## BCA & ACCESS ASSESSMENT REPORT

**PROJECT: The Forest High School**  
**PREPARED FOR: Schools Infrastructure**

Revision 1  
Date: 22 August 2022  
Reference: 210612

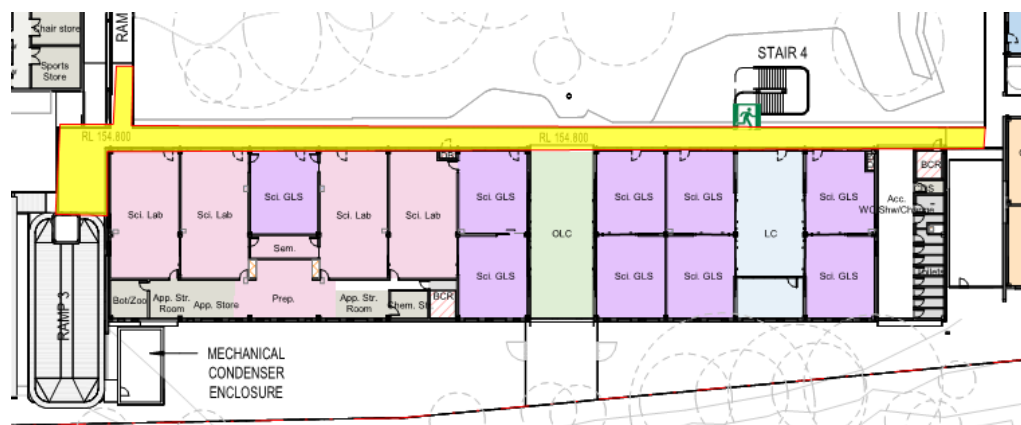
**Further Information Required:**

Block A to G are considered separate fire compartments.

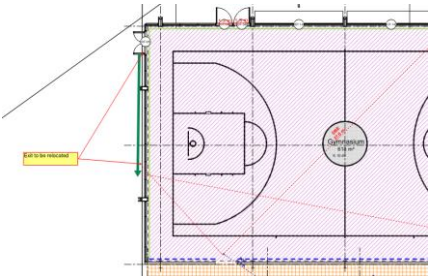
<p><b>D1.5</b> Distances Between Alternative Exits</p>	<p>Exits that are required as alternative means of egress must be-</p> <ul style="list-style-type: none"> <li>+ Distributed as uniformly as practical within the storey served.</li> <li>+ Located so that unobstructed access to 2 exits is available from all points.</li> <li>+ Not less than 9m apart</li> <li>+ Not more than</li> </ul>	<p><b>Further Information Required/ Performance Solution:</b> The following DtS non compliances were noted;</p> <p><b>Carpark:</b></p> <ul style="list-style-type: none"> <li>+ 140m between exits in lieu of 60m</li> </ul> <p><b>Lower Ground 1:</b></p>

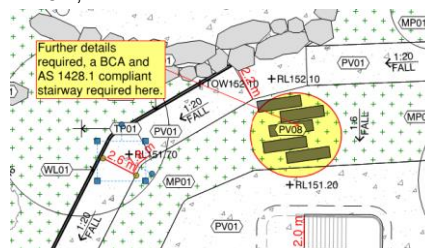
**Does not comply/Further Information Required:**

The proposed stairs in the central landscaped area must comply with AS 1428.1;

Stairway details including sections are to be provided for assessment.

**Block A**

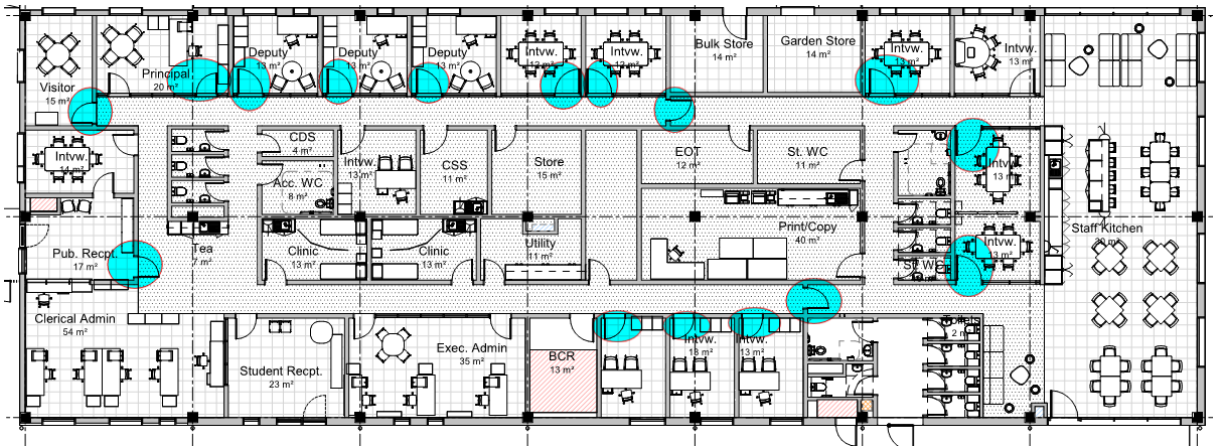
Note: Door circulation must be shown to comply with furniture layout. Desks are not considered movable furniture.

Typical all Blocks – GLS areas – Sliding Door junctions. Latch side clearance required.

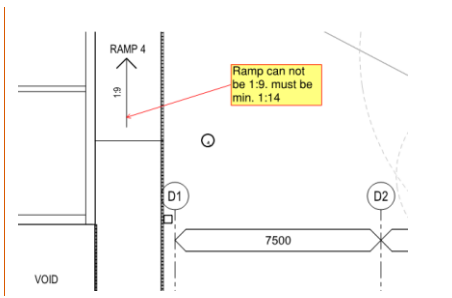
Ramp 1 appears to have a level difference of 3.9m. RL158.7 -154.8. Please confirm.

Ramp 4 indicates a gradient of 1:9. 1:14 is required to comply with AS 1428.1.

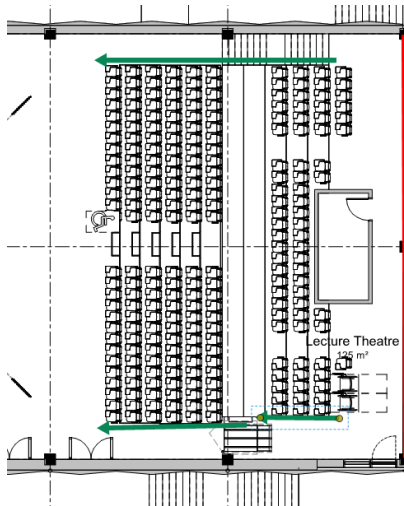
<b>NSW H101.5.1</b> Extent of stage area	If a room or area is not separated from the remainder of a conventional stage by construction having an FRL of not less than 60/60/60, the room or area is, for the purposes of this Part, to be taken to form part of the stage.	<b>Note.</b>
<b>NSW H101.5.2</b> Small stages	A stage which is more than 50 m2 but not more than 150 m2 in area must have 2 or more means of egress from the stage and backstage area provided otherwise than through the proscenium wall.	<b>Further information Required:</b> Additional exit is required from store/BOH room.
<b>NSW H101.5.3</b>	A stage which is more than 150m <sup>2</sup> in area –	<b>Further information Required:</b>

### Carpark/Lower Ground 2

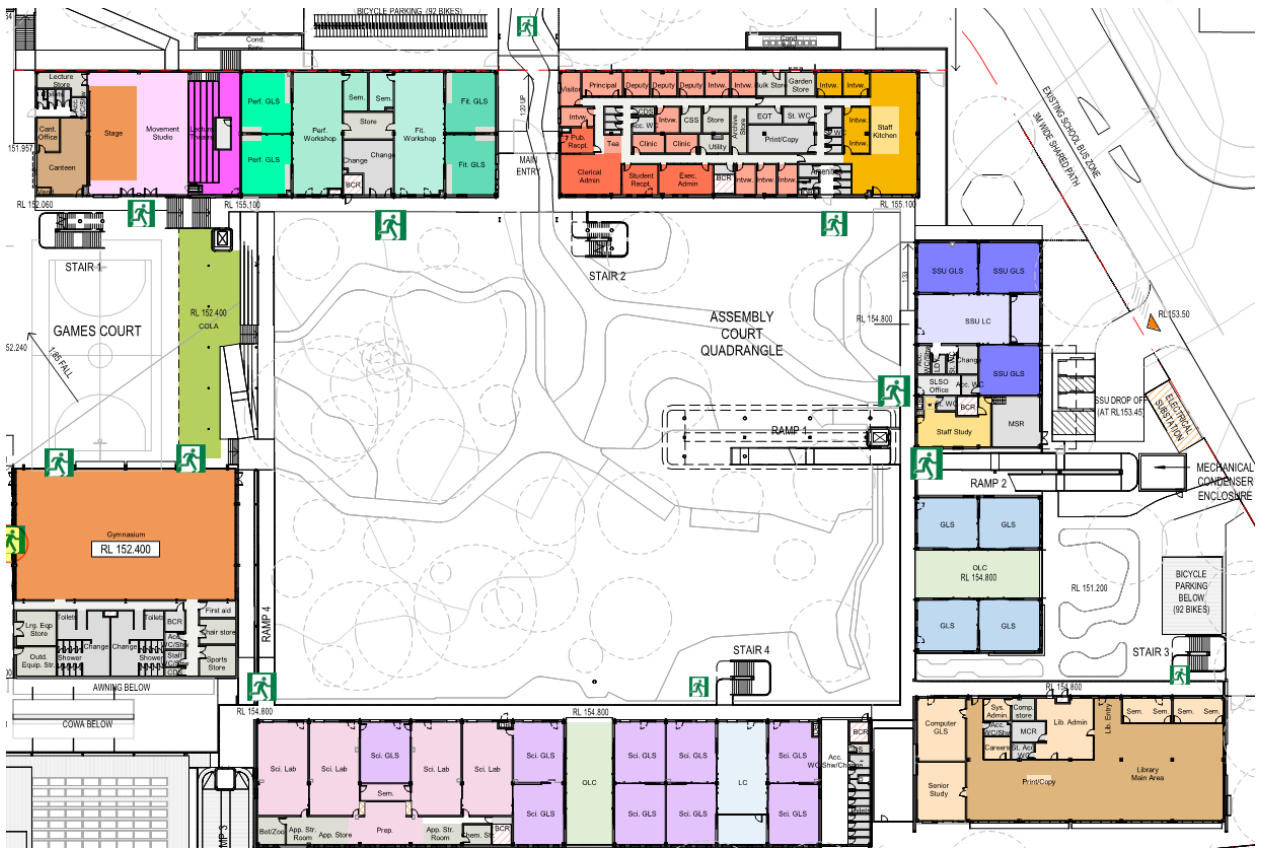
- + 75m to nearest exit in lieu of 40m

In addition, additional stairs are required to allow egress to alternative exits, as shown below;
